ADDRESS TO INDEPENDENT PLANNING COMMISSION

ST LEONARDS SOUTH PROPOSAL - 20TH MAY 2019

St Leonards South Planning Proposal

St Leonards South Transitions

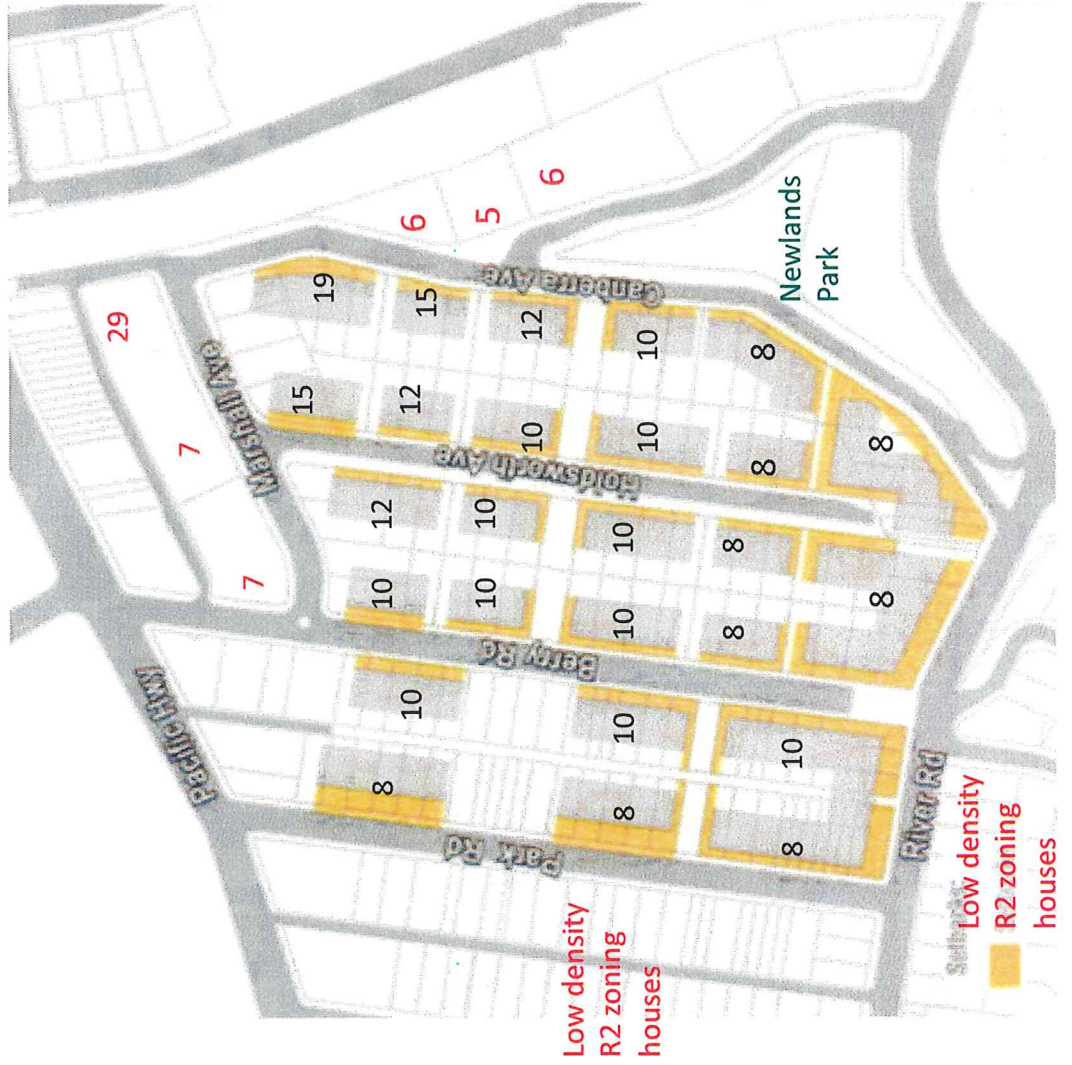
Properties at the northern end of Duntroon Avenue are 5 storeys. Immediately next door, to the north, a 6 storey apartment building is under construction at 2 Canberra Avenue.

If this plan is approved as displayed, these homes will be directly opposite 19 and 15 storey towers. This is neither fair nor reasonable.

Low density residential properties in Park Road West and River Road are opposite 8 storey buildings. Again not reasonable. And many of the residences in Marshall Avenue are 6 and 7 storeys. They will be opposite 10, 12 and 15 storey towers. Clearly inconsistent with the design principles of the draft plan.

The heights along all of the perimeter streets need to be significantly reduced so that existing residents are not swamped by new development.
